Project Name: Mt. Hope School – New BuildProject No.: 221125-140Architect: C2AEDate: 7/31/2023Bid Package No.: 2Bid Due Date: 08/03/2023

Addendum 3

Project No.:	22-0116	Date:	July 28, 2023
Project:	Mt. Hope Lansing School District SB-1785 Ingham County, MI	A/E Firm:	C2AE
Owner:	Lansing School District 519 West Kalamazoo Street Lansing, MI 48933	Project Manager:	Steve Jurczuk

FIRST FLOOR FINISH PLAN - OVERALL
3/32" = 1'-0"

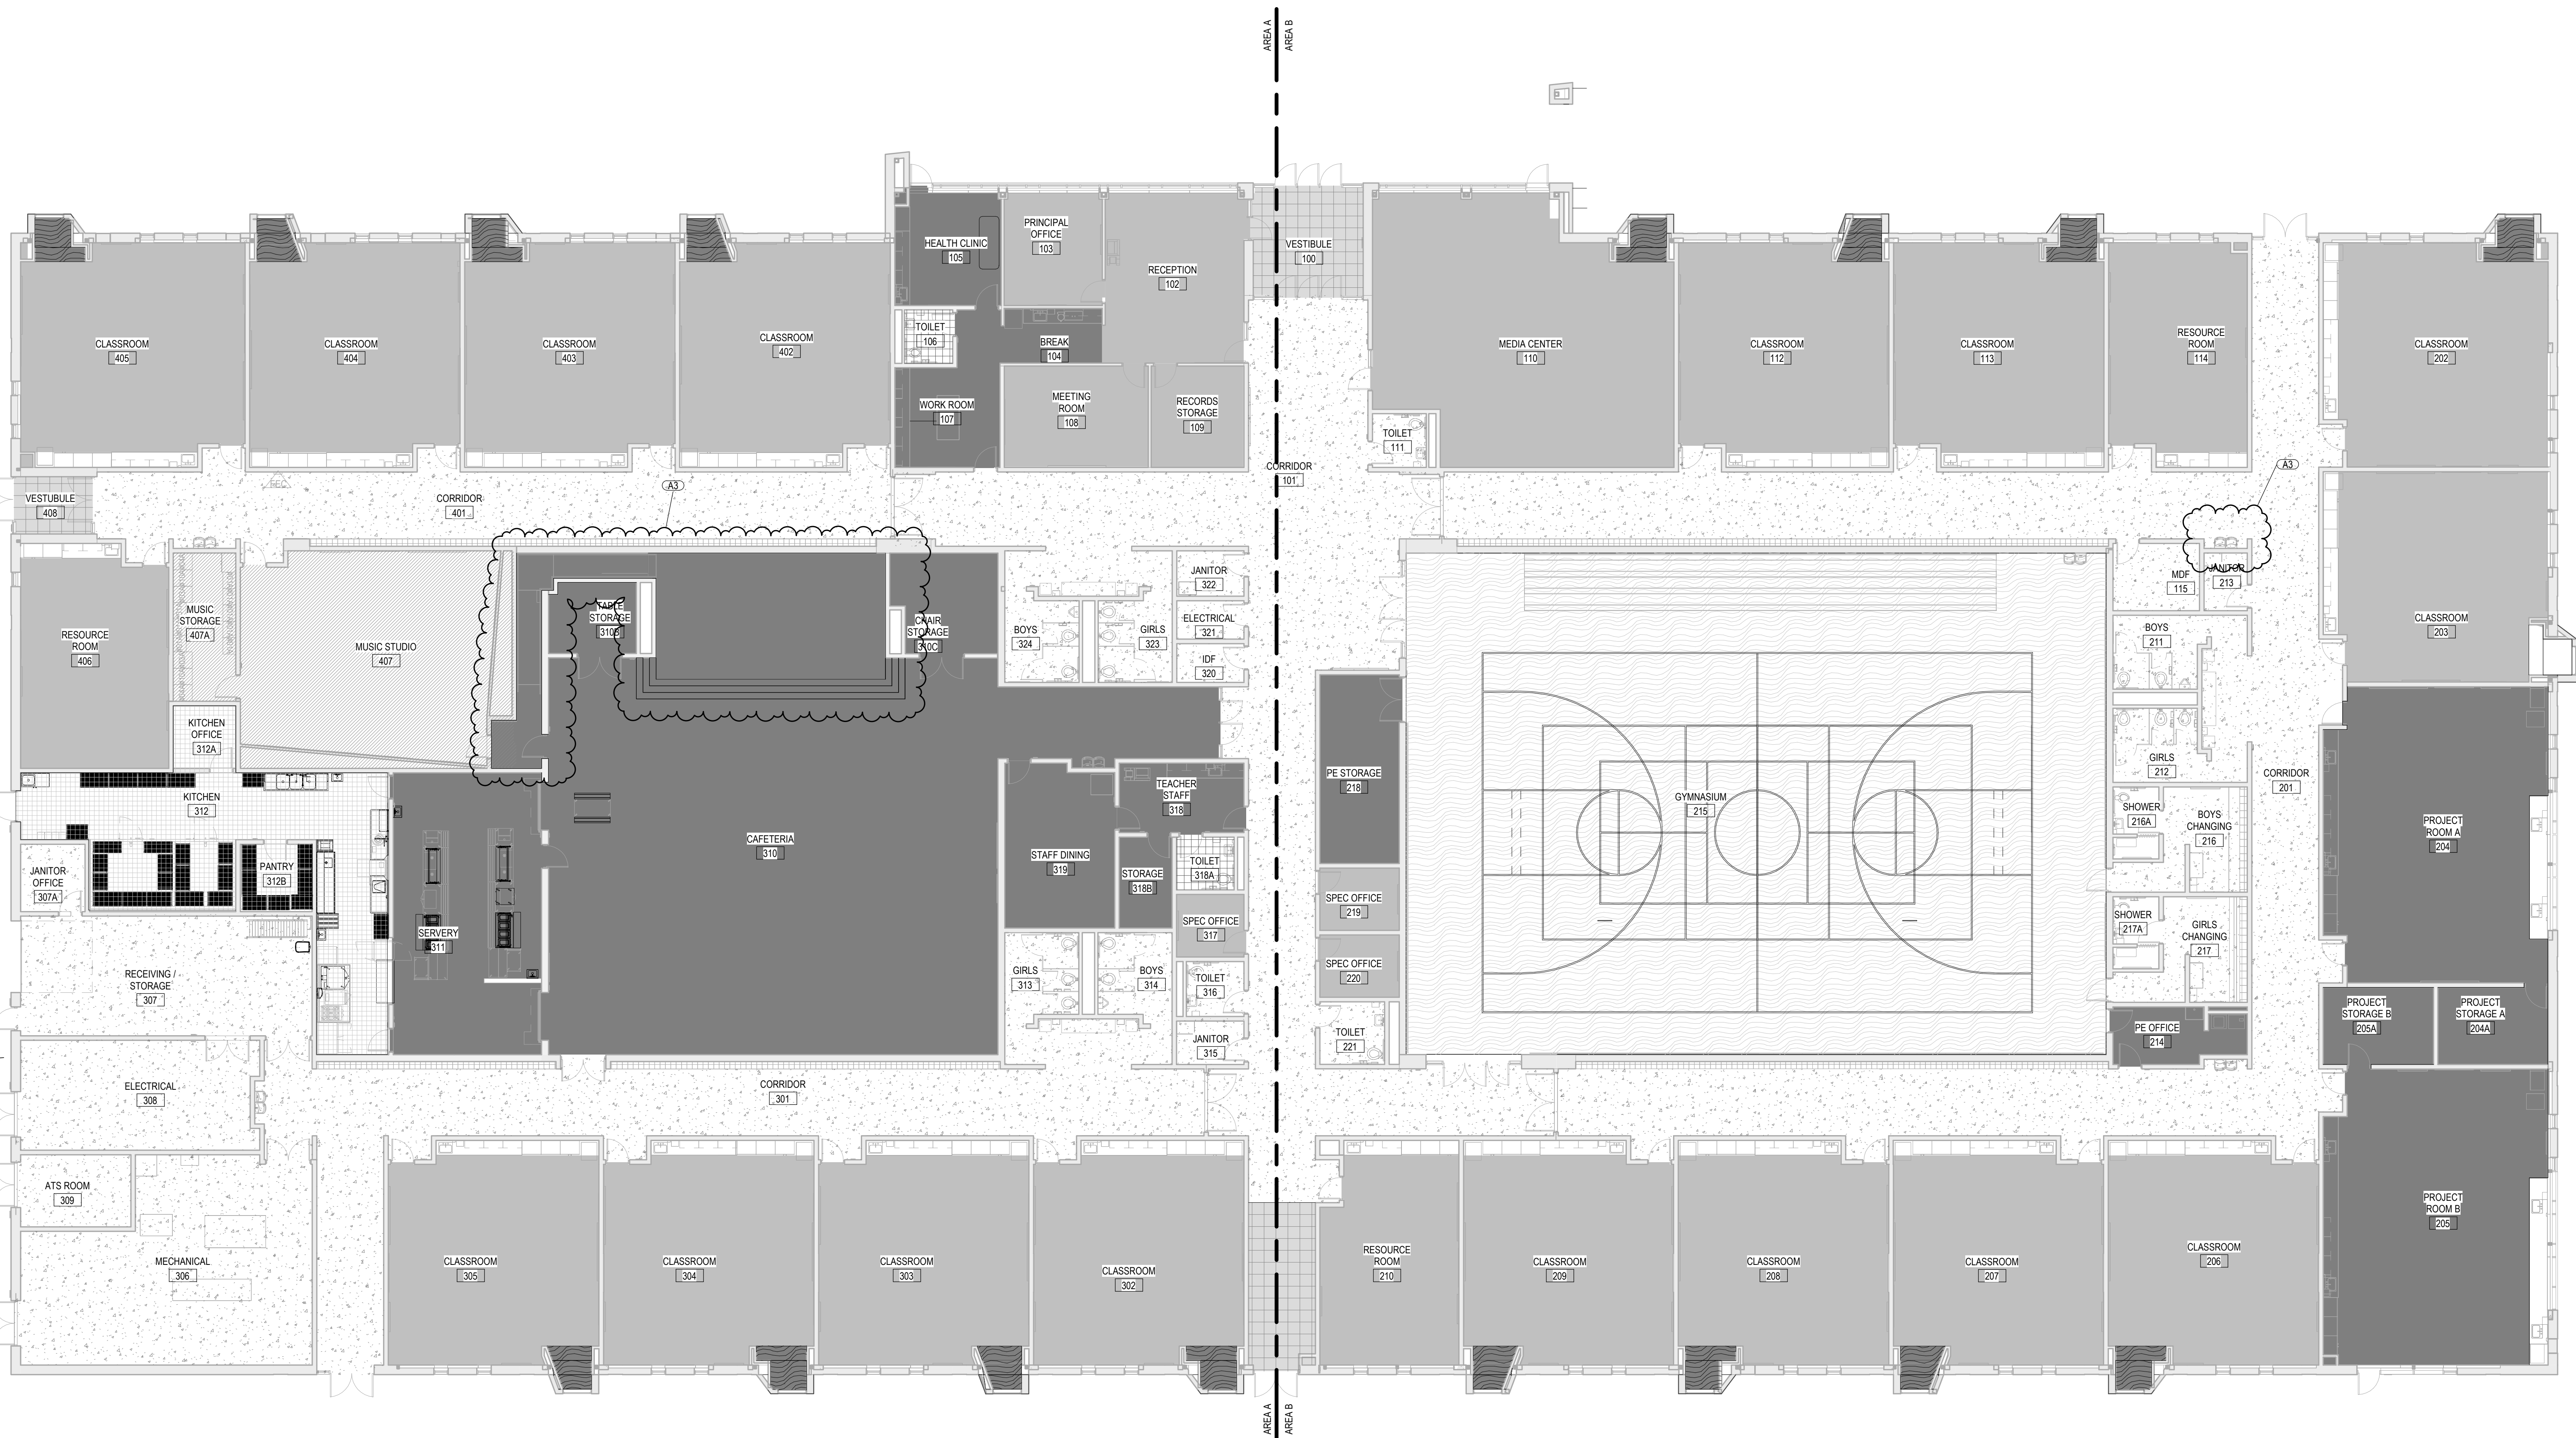
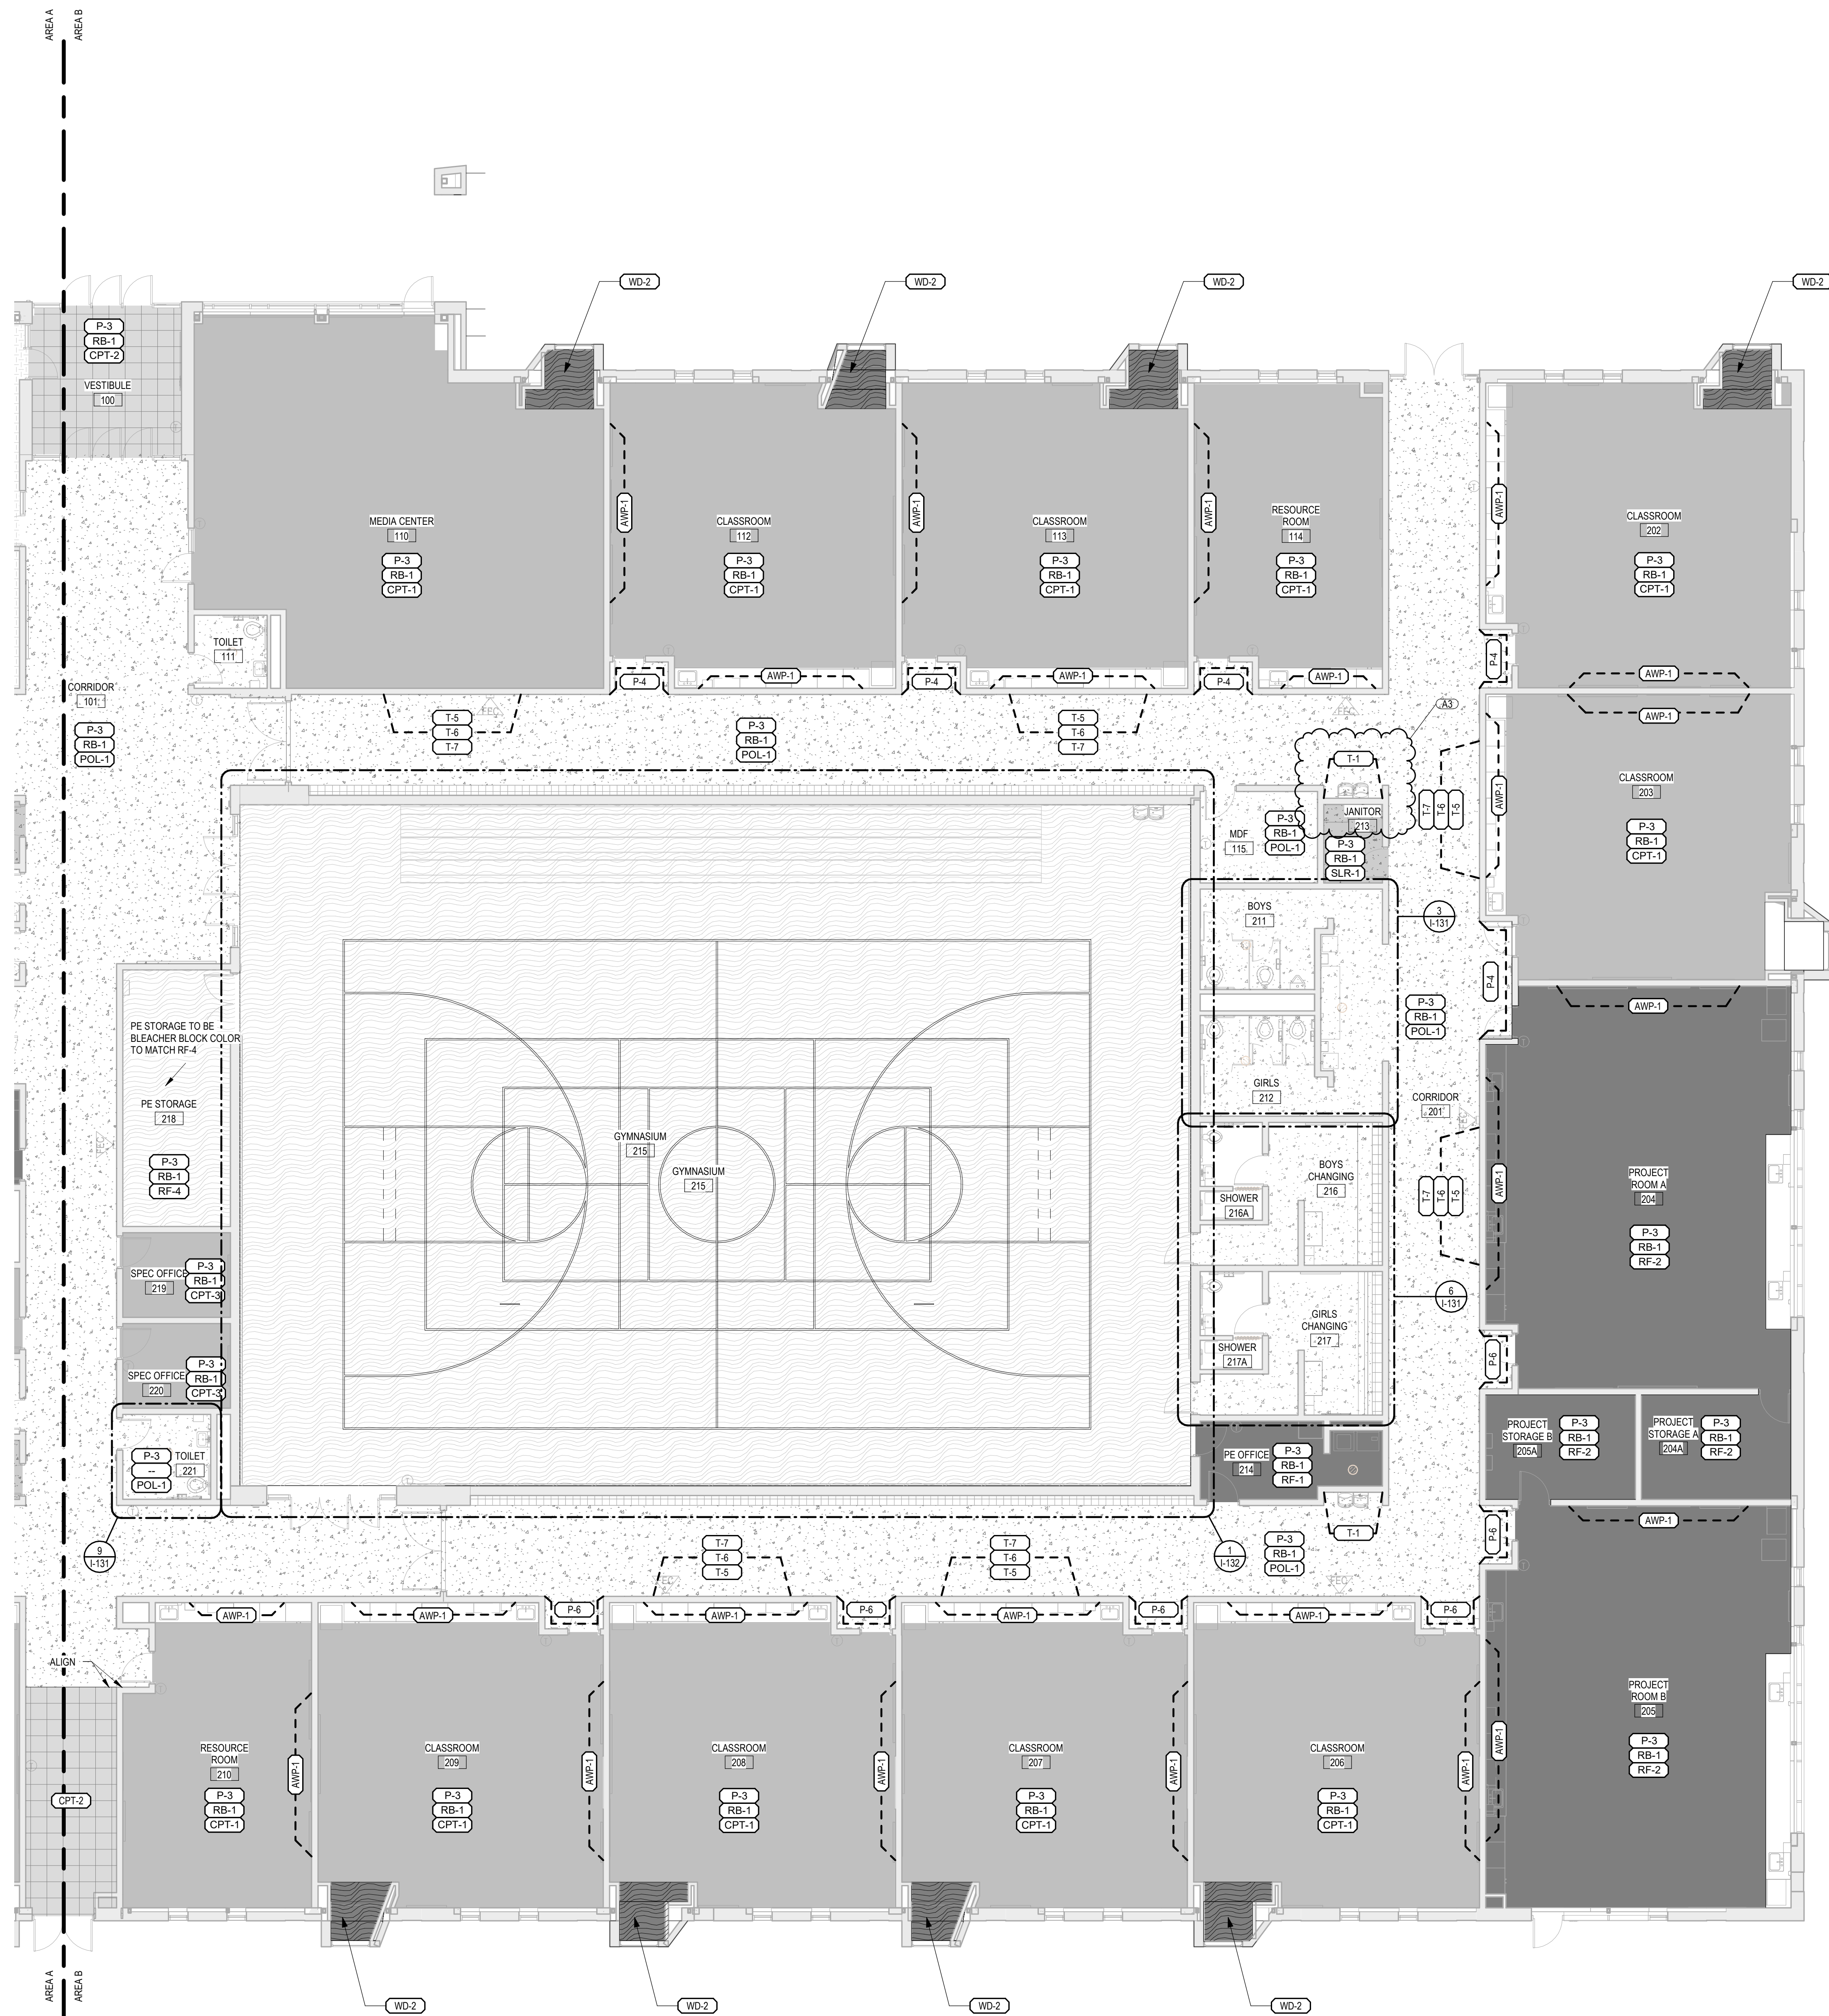
6. Add ACP-3 to materials schedule. Armstrong Optima, White in a White grid, 24"x24"x1", 15/16 grid.
- A3.17 Refer to Sheet I-101 (reissued):
1. Floor hatching for cafeteria stairs, stage and ramp modified to reflect RF-2.

2. Tile wall accent notation added to water fountain in 201 Corridor adjacent to Janitor 213.
 3. Resilient base for cafeteria stage area modified to reflect RB-1.

UNDERGROUND PLUMBING PLAN - AREA A
1/8" = 1'-0"

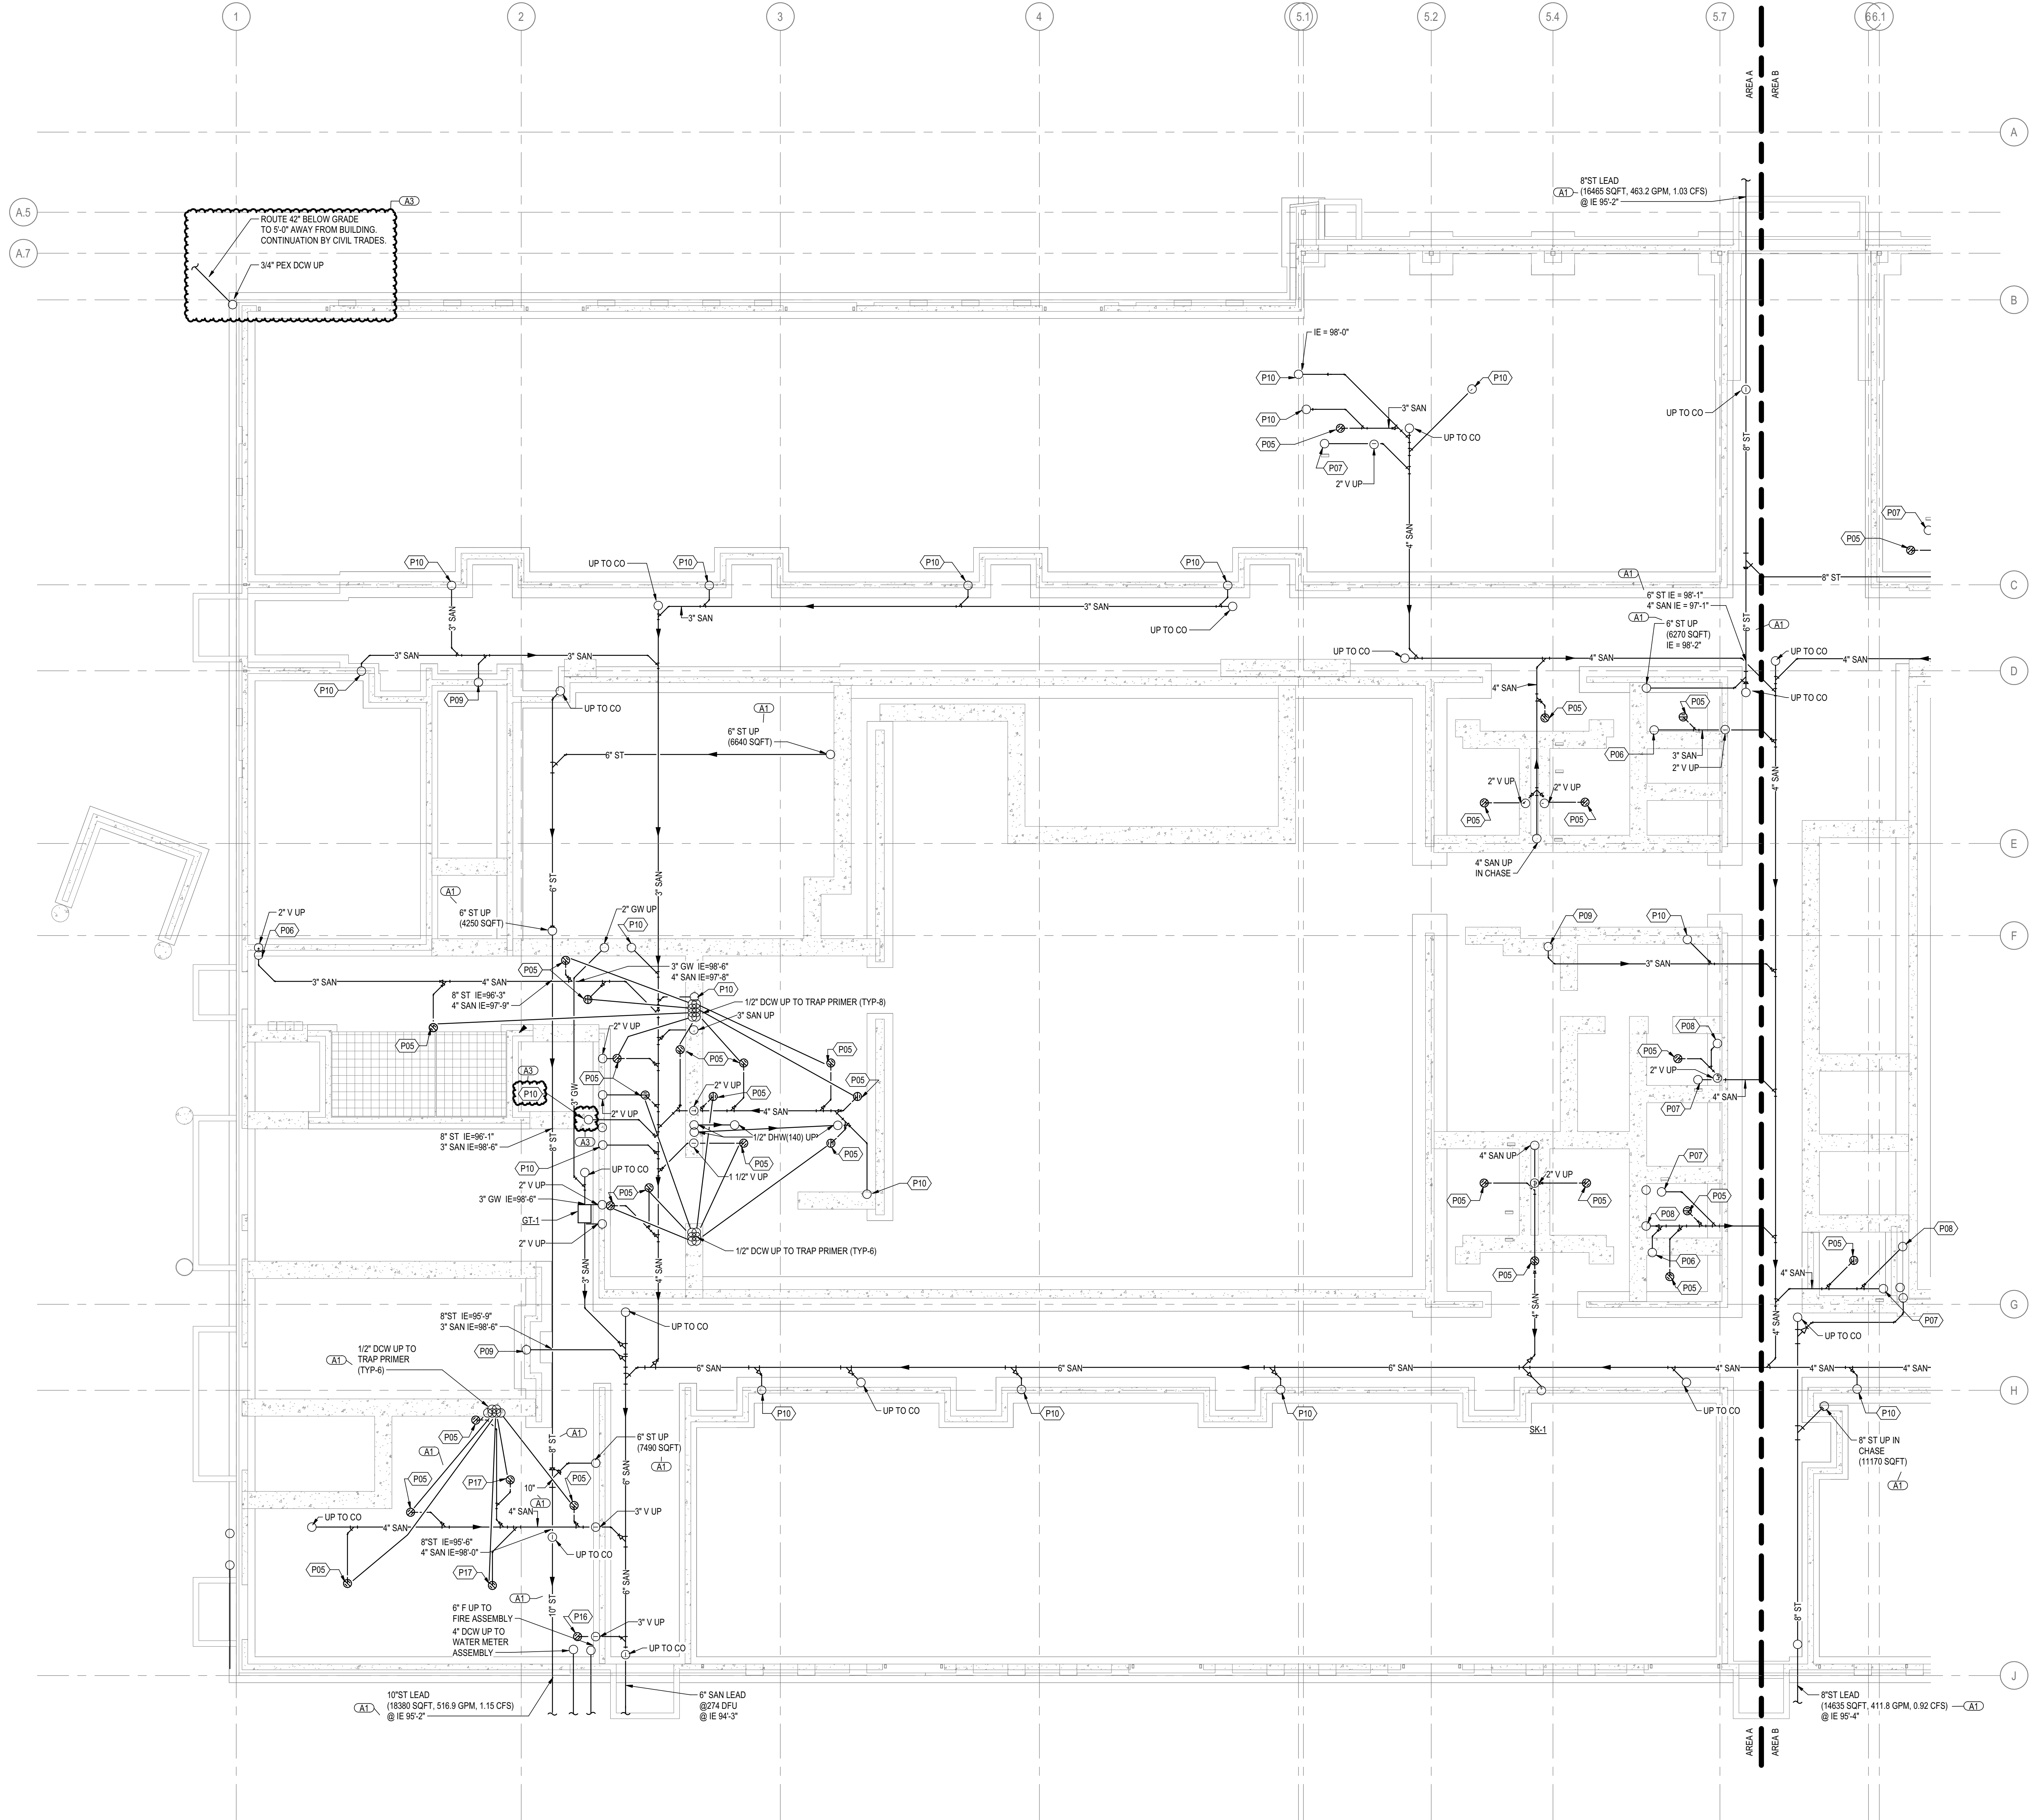
1. Change keynote from P06 TO P10 as shown near G/2.
 2. Add underground irrigation piping as indicated at NE corner of building.
- A3.21 Refer to Sheet P-111A (reissued):
